FSAE EV @ UCI

Anteater Electric Racing

RTM (Ready-To-Move) PCB Modifications

Andy Li

Potential Issues

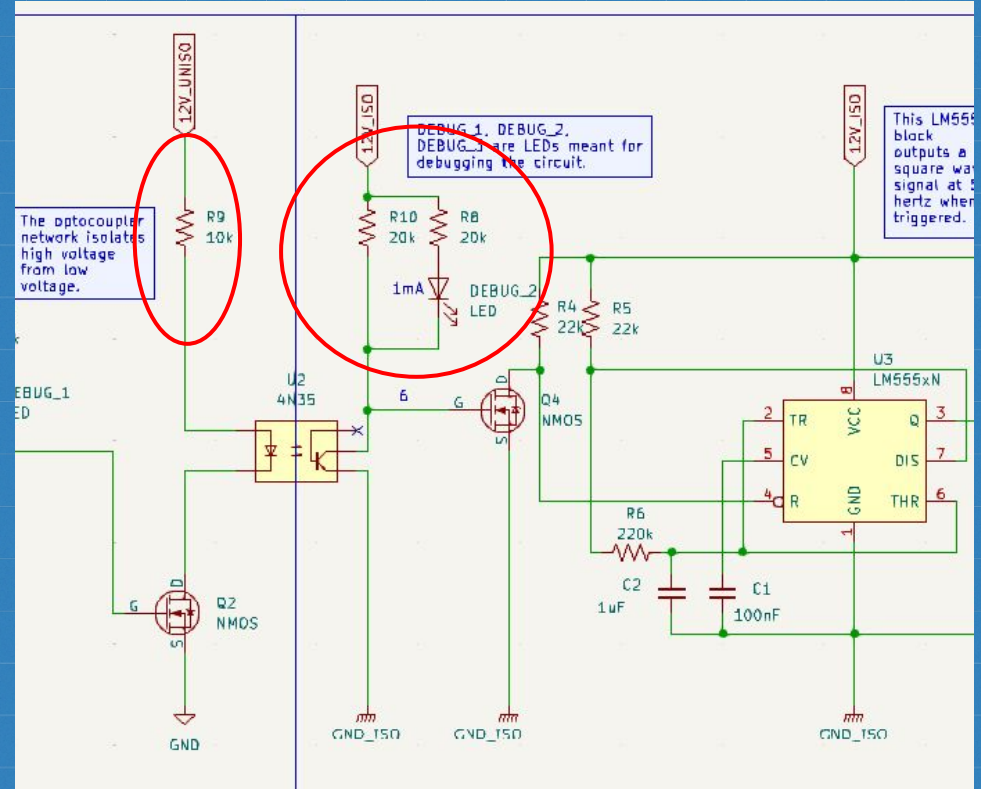
- Concern at the time was because I believed that the Q4 NMOS would always be on, leaving the Reset pin on the 555 timer always asserted (GND) -> LED signaling RTM never flashes

Simulation of Current Design

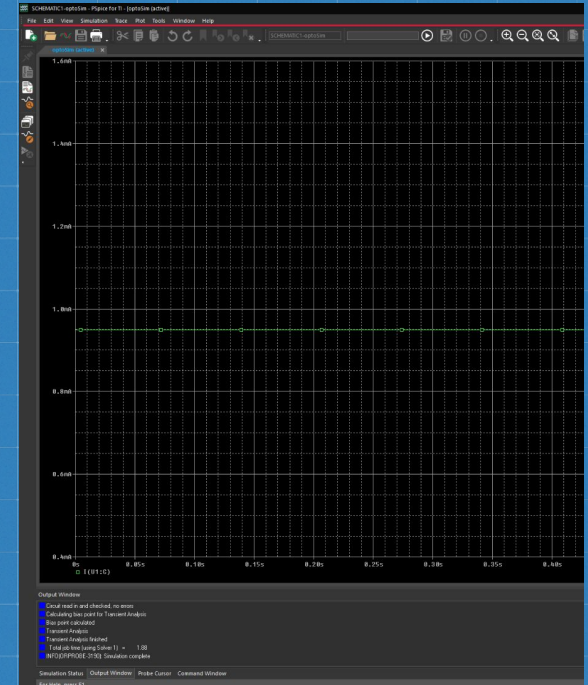
- Albert said that the V_{TH} of these MOSFETS is $\sim 3V$, so a $2.4V$ gate voltage should technically work for the MOSFET
 - This is probably why the PCB works right now
 - May also explain why Albert said that the board acted unusually without some additional components
 - This $V_G = 2.4V$ leaves no margin for error; the MOSFET may not be fully off for $V_{GS} = 2.4V$, the true V_{TH} of the MOSFET may be lower, resistor tolerances could cause the gate voltage to increase beyond $3V$, etc.

Improvements

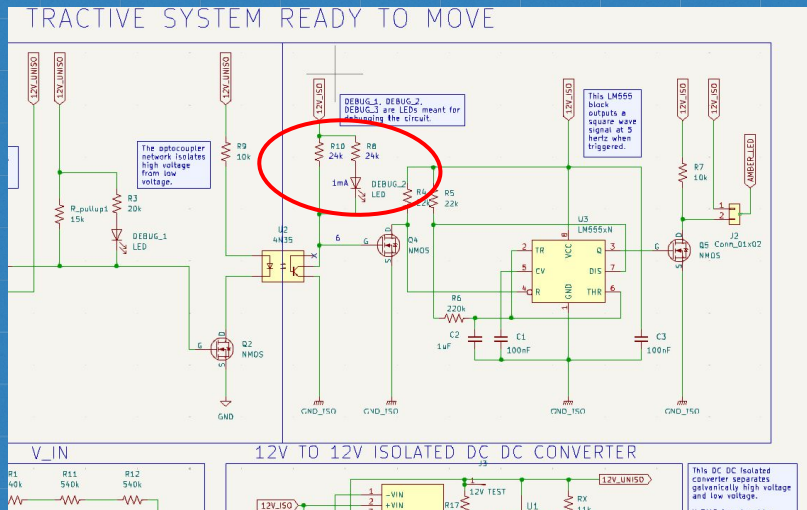
- Given that the PCB works as is, there is technically no need for any changes
- However, given that we've already come so far, I strongly suggest increasing the R10 and R8 resistors to $24\text{k}\Omega$ each, giving an equivalent $12\text{k}\Omega$ resistor
 - This will result in a much safer margin of error for V_{GS} of the Q4 NMOS
- Minimal change that requires little effort, so I don't believe there is a reason not to do this

Simulation of Proposed Changes

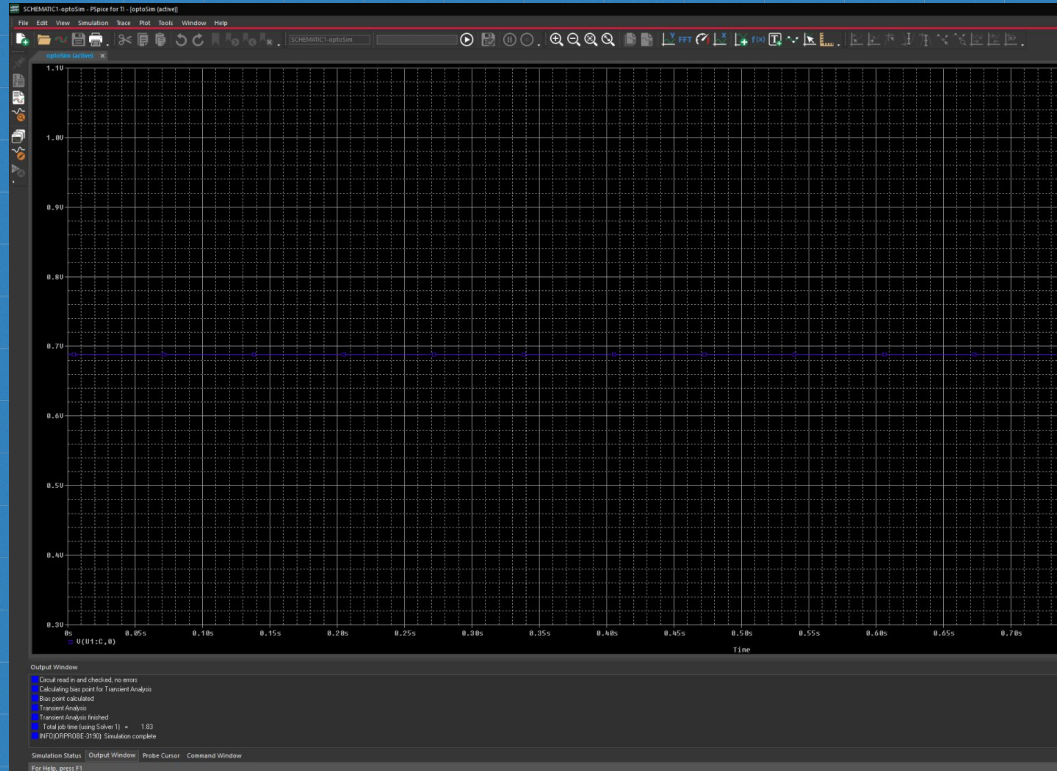
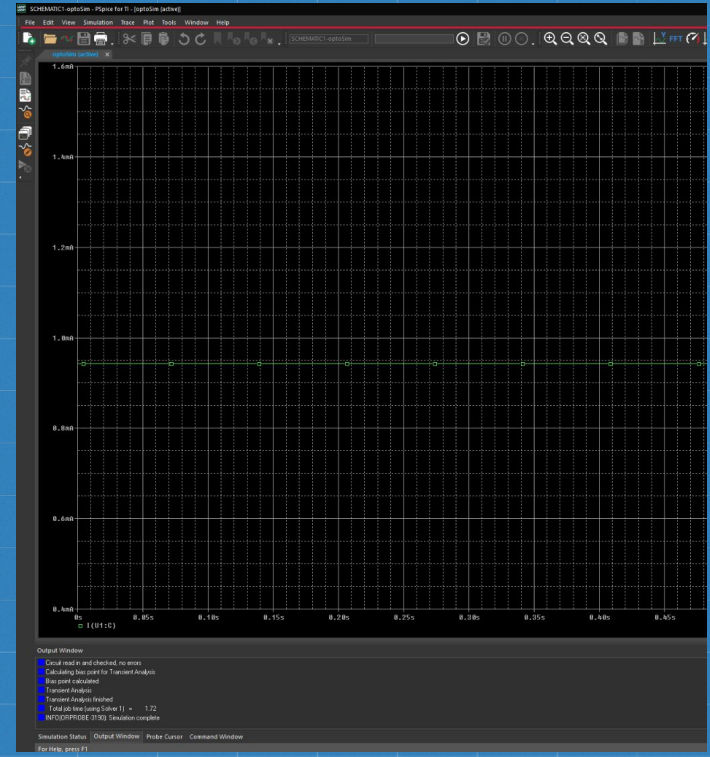
- V_{GS} for the Q4 NMOS will be at most 0.7V when the Q2 NMOS turns on
 - Provides a significant margin of error for the 3V threshold voltage of the MOSFETs on the PCB, and will ensure that the PCB works properly every time it is needed
